MEMORANDUM

Re: 1410 South Huron St., Special Land Use/Preliminary Site Plan for True Credit Union

Preliminary Site Plan and Special Use Review For Ypsilanti Township, Michigan

Applicant:	True Community Credit Union (Represented by Heather Colonius)
Project Name:	True Community Credit Union Development and Drive-Through
Plan Date:	April 13, 2026
Latest Revision:	August 25, 2026
Location:	1410 S. Huron St. (On west side of S. Huron Street, just north of Culver's site) Note: The address of this site is 1410 S. Huron St. (per MapWashtenaw)
Zoning:	FB, Form Based District – Town Center; Site Type D
Action Requested:	Preliminary Site Plan and Special Use Approval

1
E010
ELECTRICAL SITE PLAN
1/16\"/>

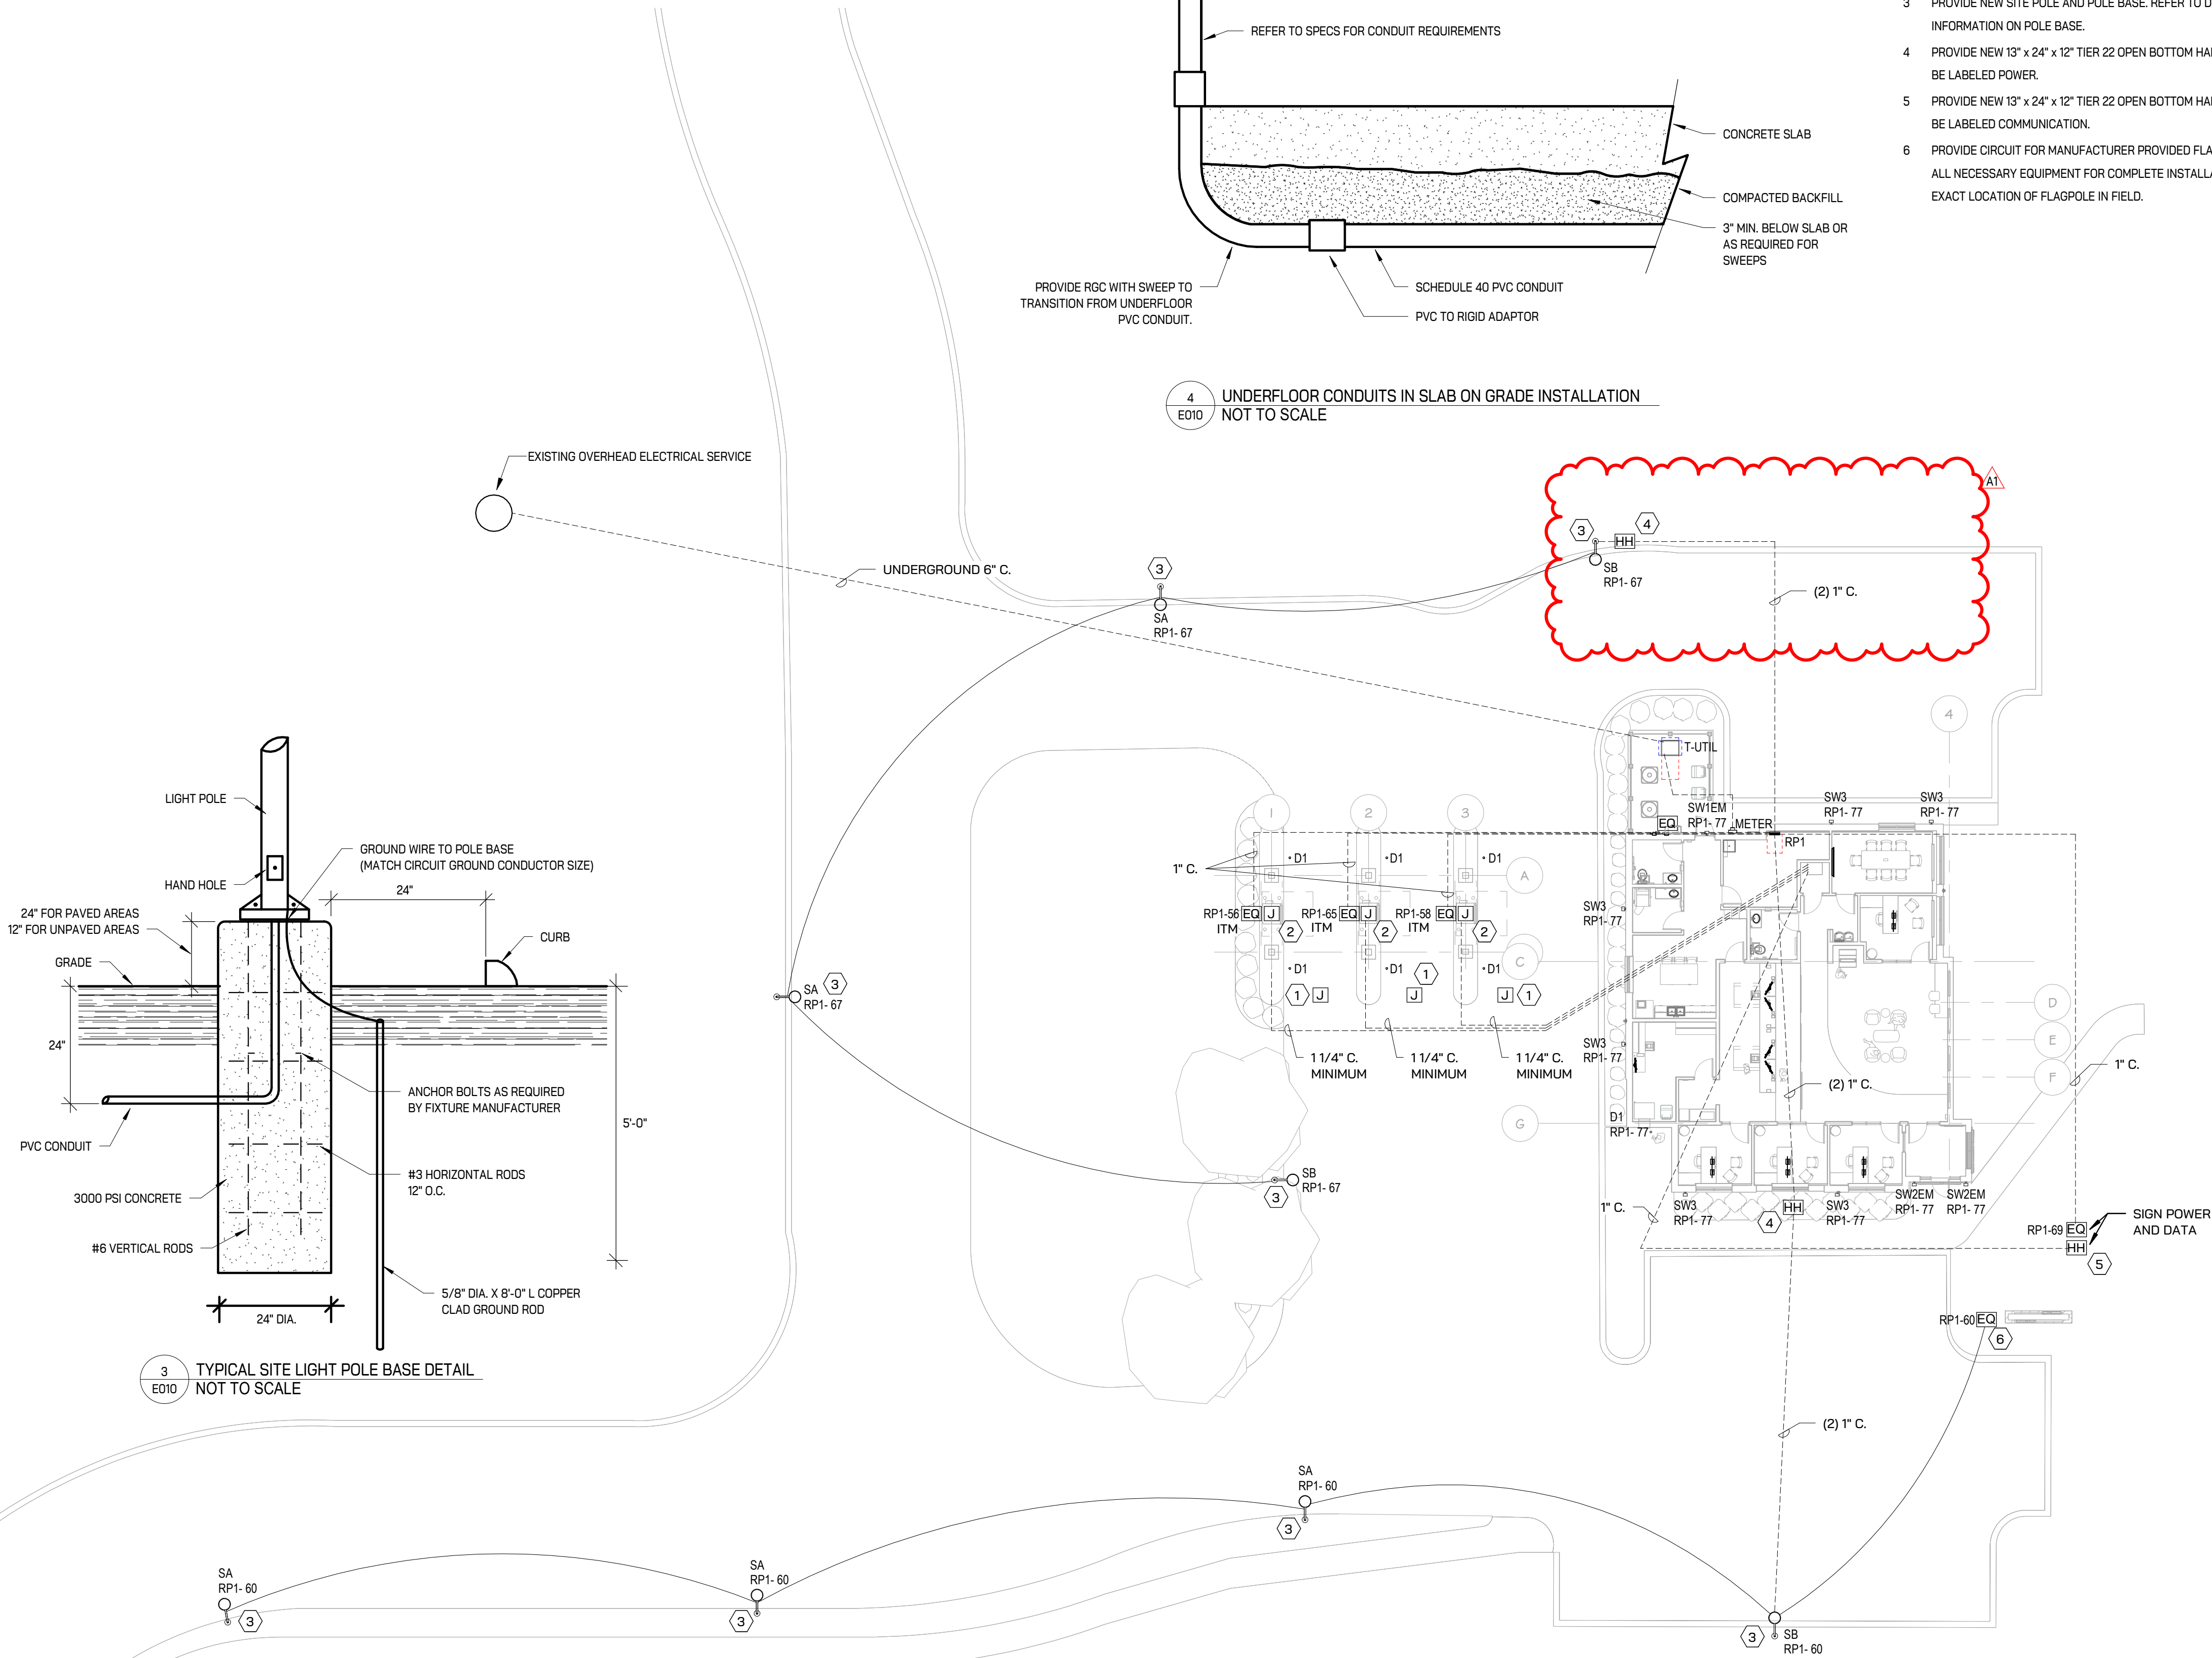
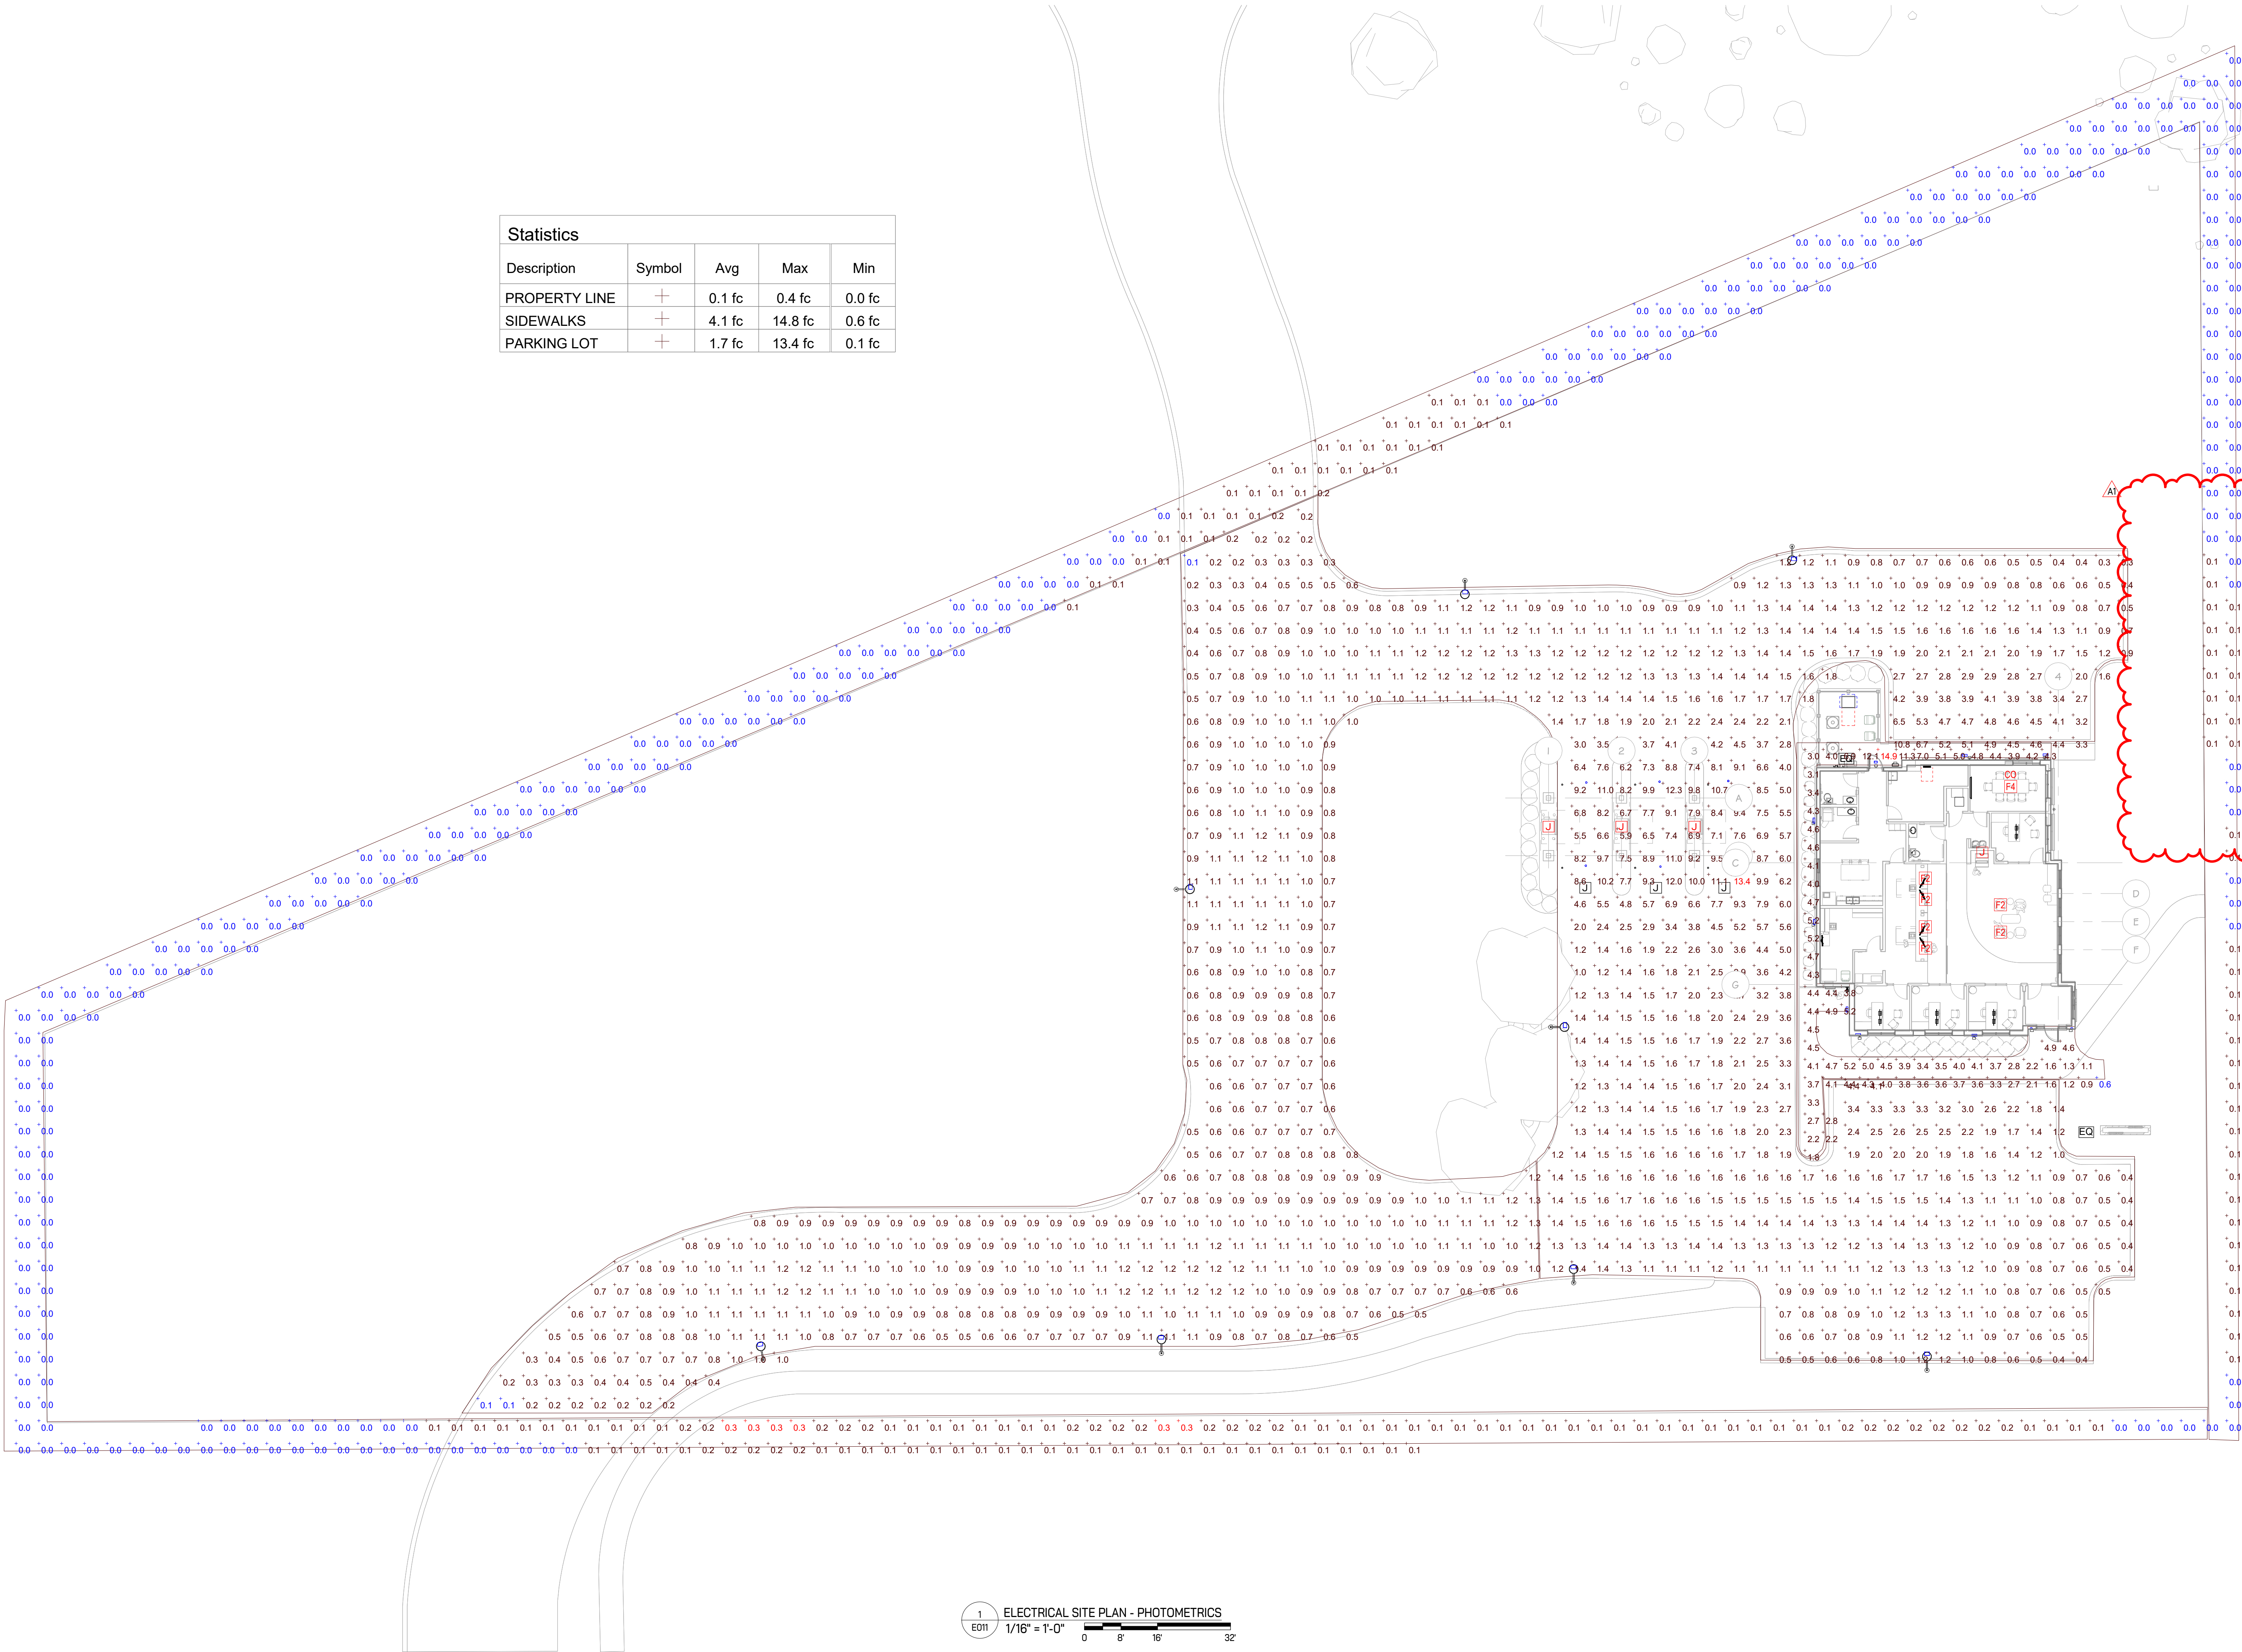
Lighting information has been submitted that includes locations of proposed light fixtures, a photometric plan showing proposed lighting levels, manufacturer cut sheets of the proposed light fixtures, and a schedule of fixture specifications (Sheets E010 and E011).

The most recent parking lot layout and building location are not reflected on the Sheets E010 and E011. These sheets need to be updated, and this can be accomplished at the Final Site Plan stage.

Items to be Addressed: 1) *Revise parking lot layout and building location on Sheets E010 and E011 to illustrate the most up-to-date site design at Final Site Plan stage.*

- d. Add quantities of each proposed plant species to the Landscape Plant List table on Sheet C6.0.
 - e. Revise parking lot layout and building location on Sheets E010 and E011 to illustrate the most up-to-date site design.
